Contract #: 04-0120F4Cty: SF/ALA Rte: 80 PM: 13.2/13.9File #: 69.25B**QUALITY ASSURANCE -- NON-CONFORMANCE REPORT****Location:** Changxing Island, Shanghai, P.R. China**Report No:** NCR-000229**Prime Contractor:** American Bridge/Fluor Enterprises, a JV**Date:** 13-Feb-2009**Submitting Contractor:** Zhenhua Port Machinery Company, Ltd (ZPMC), Changxing Island**NCR #:** ZPMC-0204**Type of problem:**

Reference Description: Missing MT inspections after grinding of arc strikes**Description of Non-Conformance:**

Job Name: SAS Superstructure

Subject: NCR No. ZPMC-0204

NCR #: ZPMC-0204

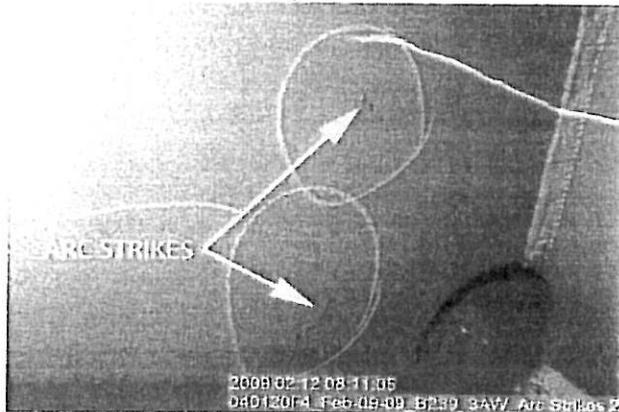
Reference Description: Missing MT inspections after grinding of arc strikes

QA Inspector performed a preliminary random visual inspection after the grit blast of the internal components of the bottom panel and side panel super assemblies of segment 3AW. Arc strikes were found in various locations on the bottom and side plating components. ZPMC QC personnel were made aware of these locations and repairs were made by grinding without carrying out magnetic particle inspection as per section 9.2.2.1 of the ZPMC Welding Quality Control Plan (WQCP).
